## Addendum #2

**Project Name:** Randolph Elementary Additions & Renovation  
1024 S. 37<sup>th</sup> Street  
Lincoln, Nebraska 68510

**SHA Project No.:** 15049-05  
**LPS Bid No.:** 8366  
**Date Issued:** February 12, 2016

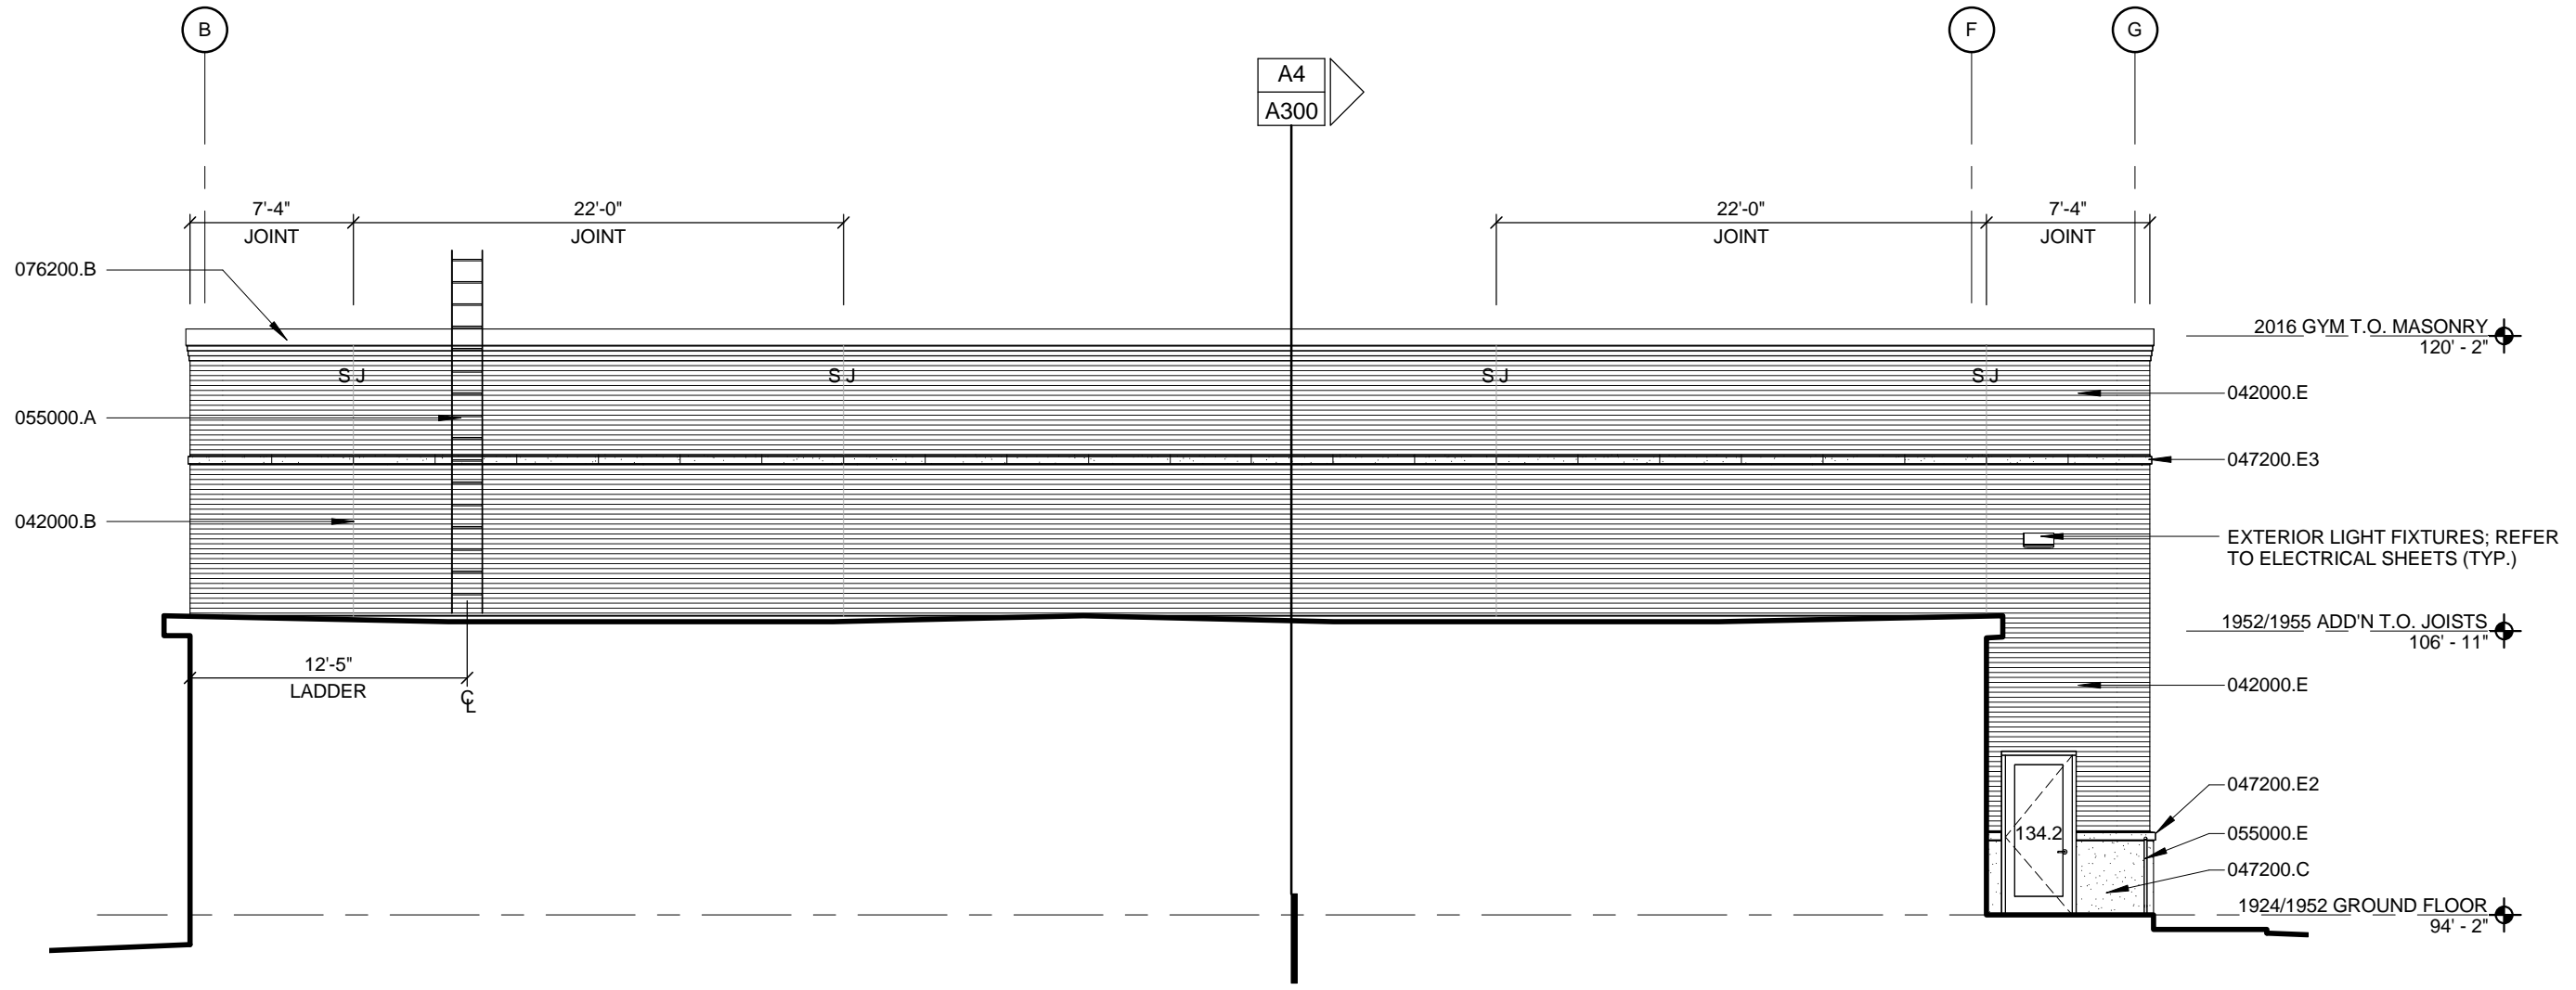
**ADD 1-12.** West elevation to new gymnasium addition was never provided in the final documents. We are providing this elevation as part of this addendum. Elevation will not fit on Sheet A200 and rather than issue an entire new Sheet A201, we have issued this elevation on an 11x17 attachment. See **Attachment A1**.

# L8 KITCHEN PLUMBING RISER

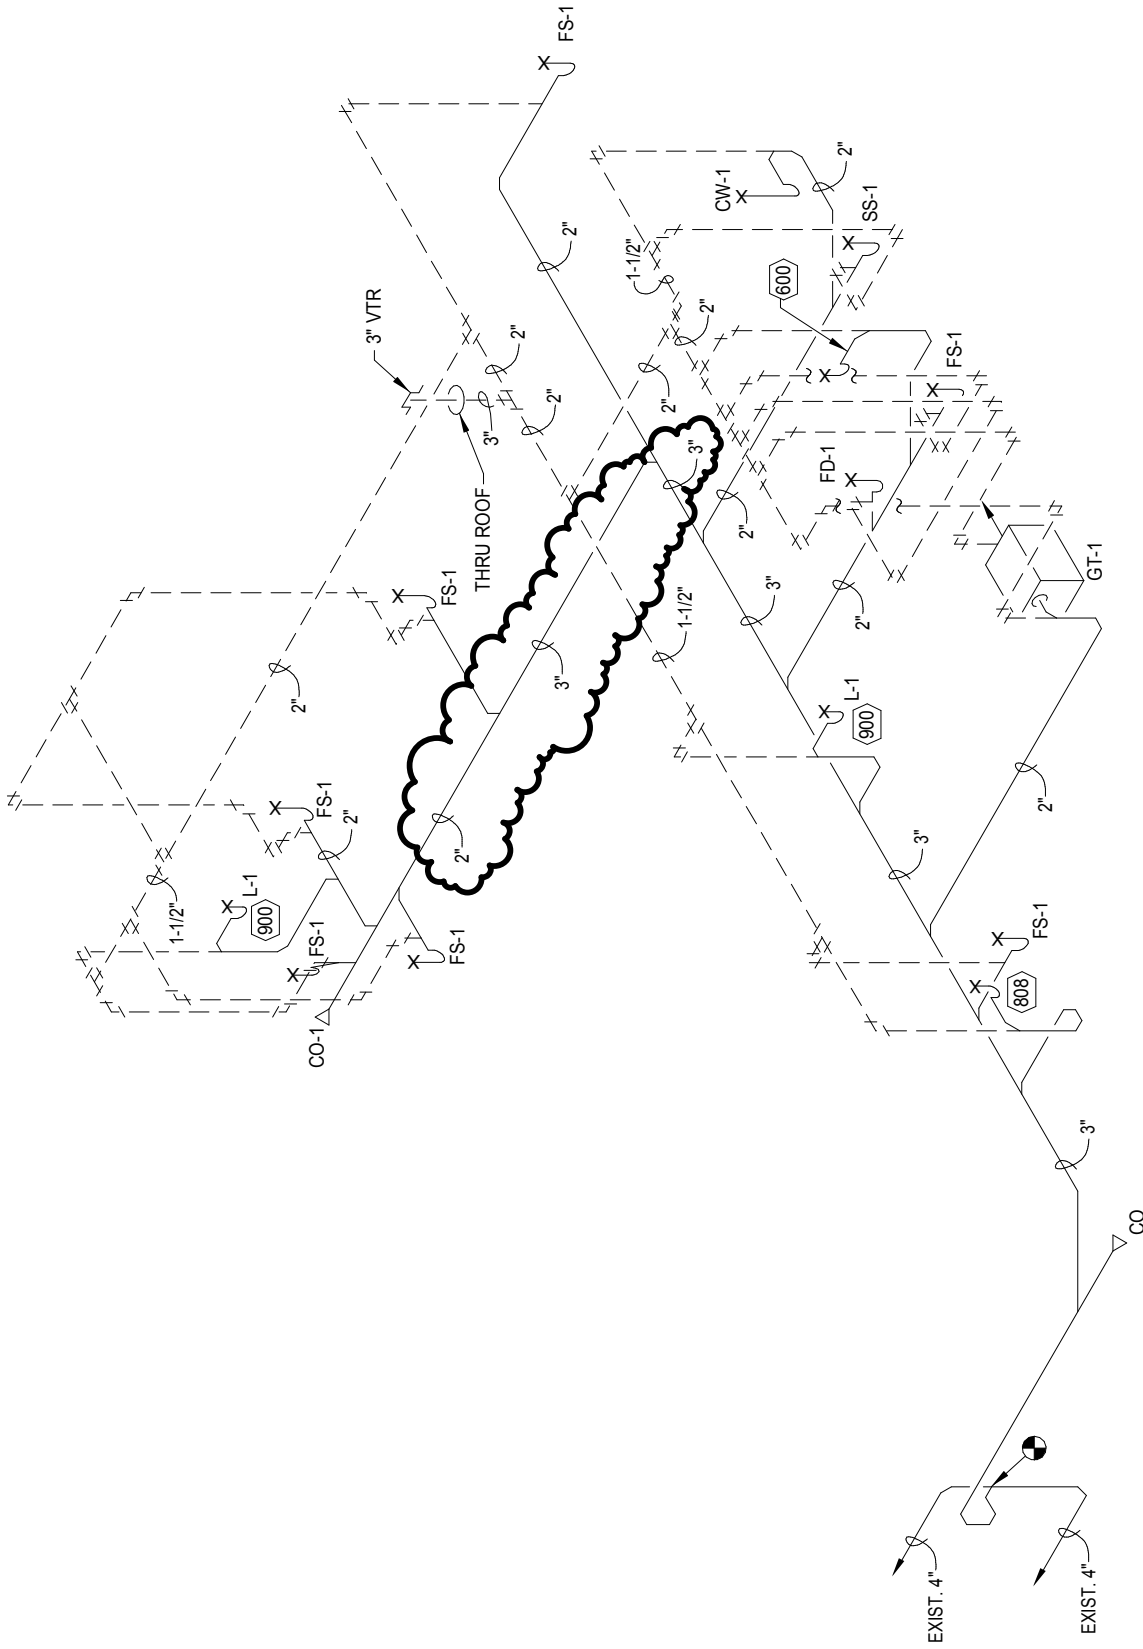
**ADD 1-16.** Refer to Sheet M101, Detail L8; Some 2" drain lines have been upsized to 3". Refer to **Attachment 1/M101**

# L12 LIBRARY RR PLUMBING RISER

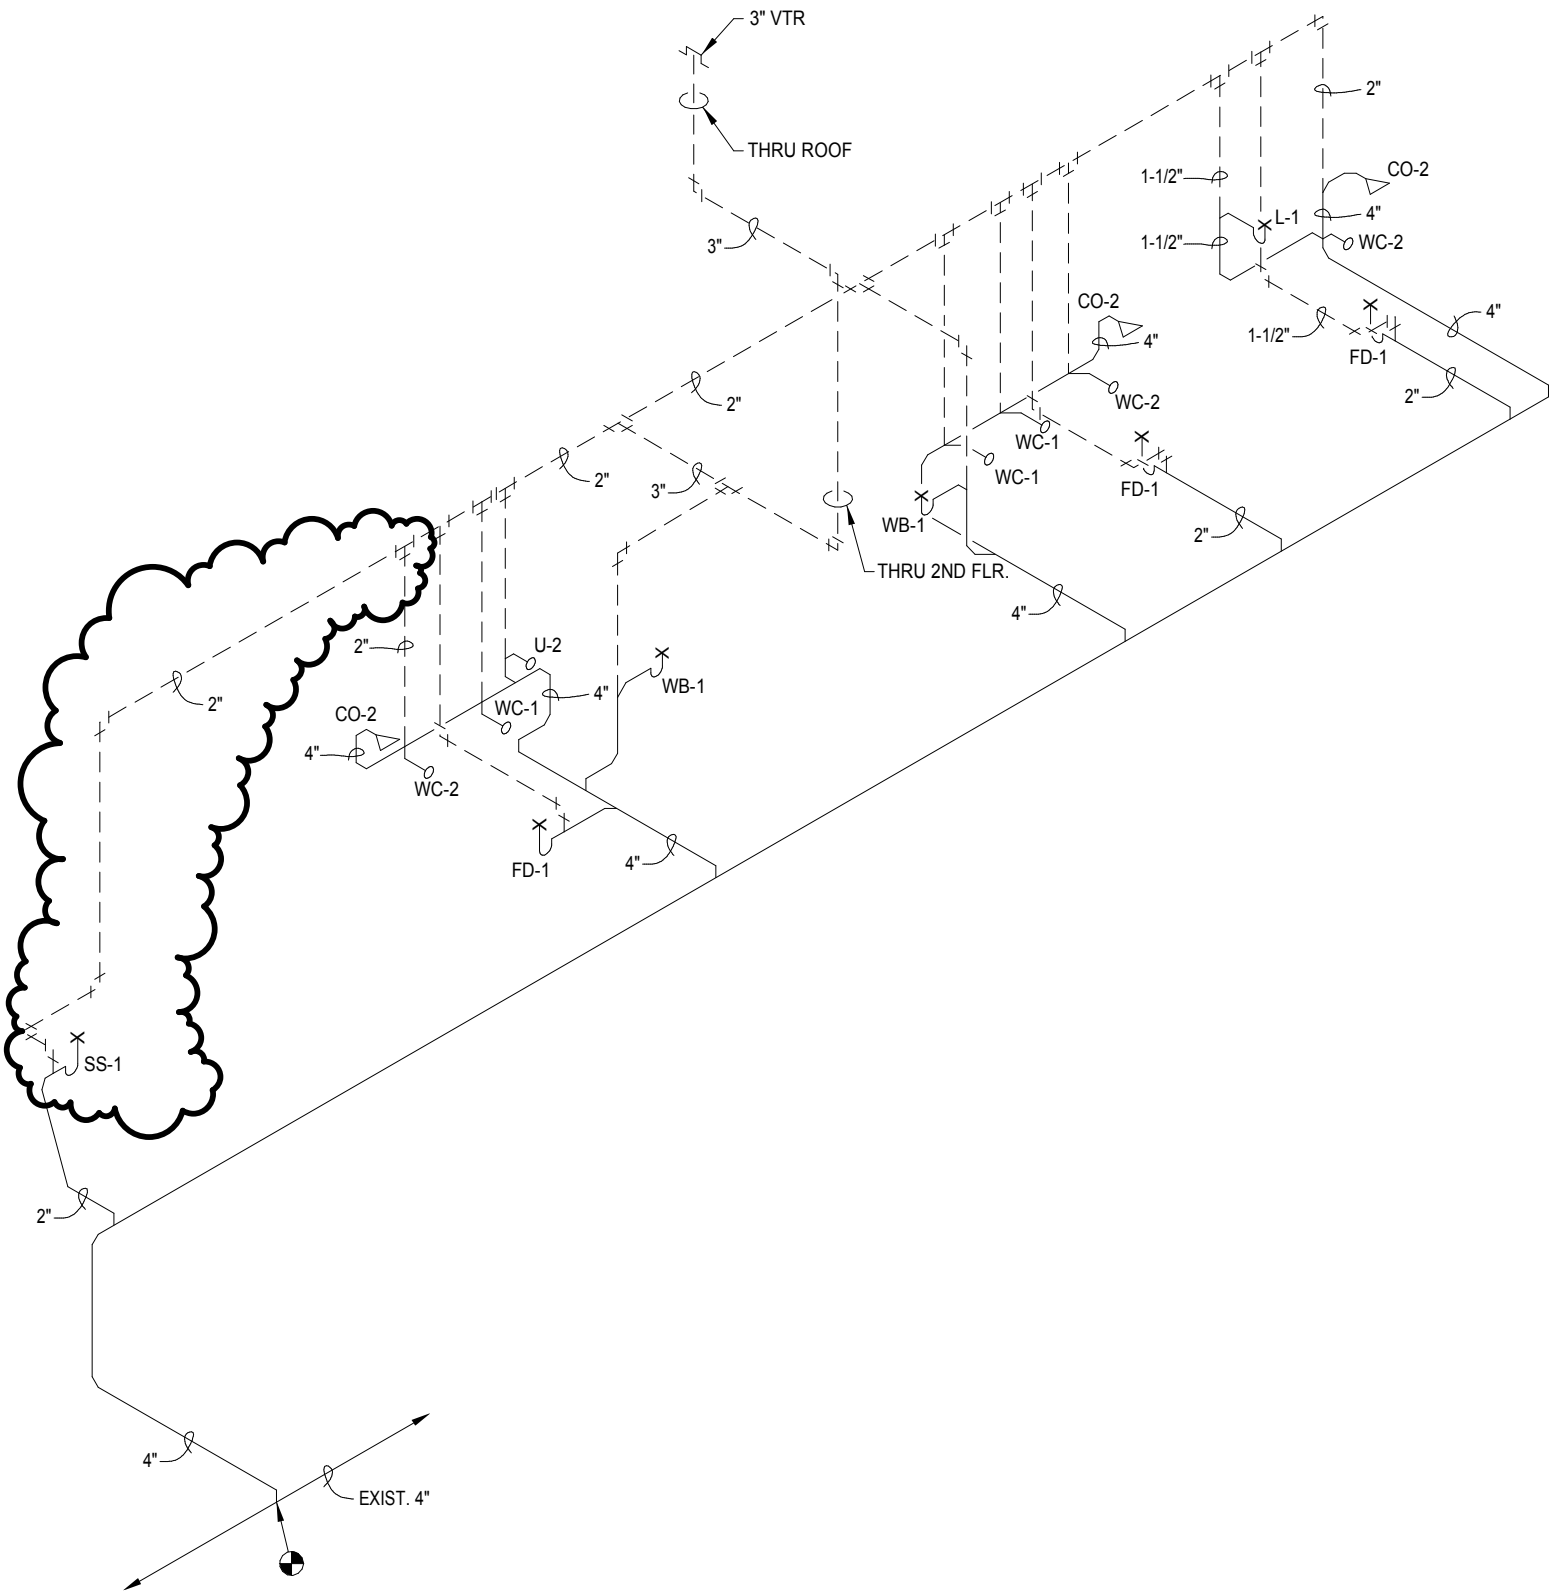
**ADD 1-17.** Refer to Sheet M101, Detail L12; A plumbing vent was added. Refer to **Attachment 2/M101**

# J4 AREA B PLUMBING RISER

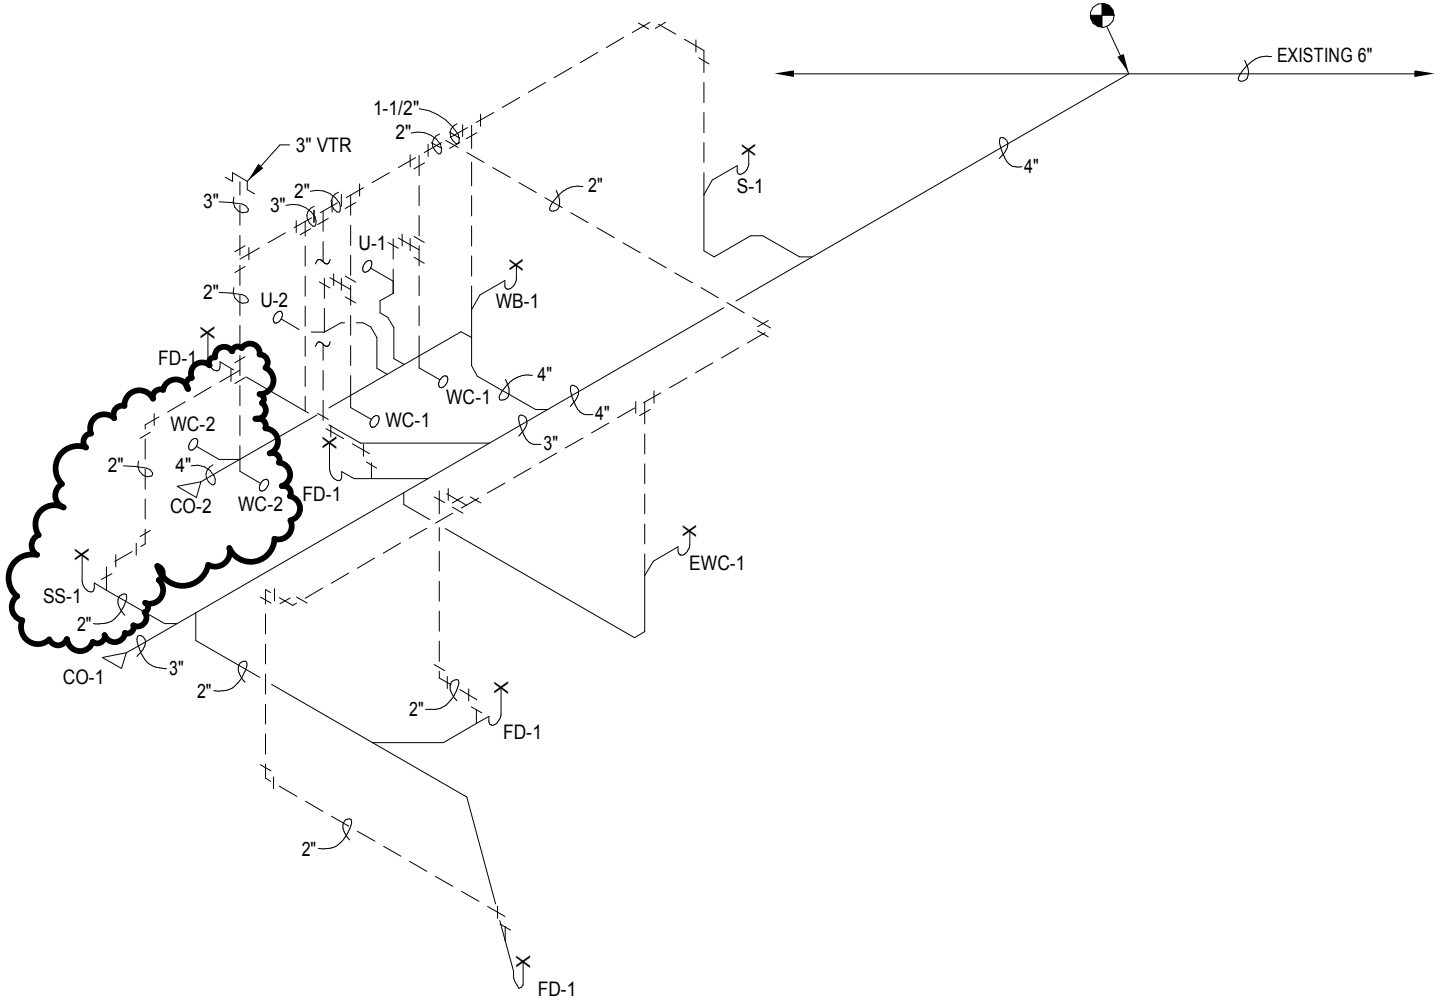
**ADD 1-18.** Refer to Sheet M102, Detail J4; A plumbing vent was added. Refer to **Attachment 1/M102**
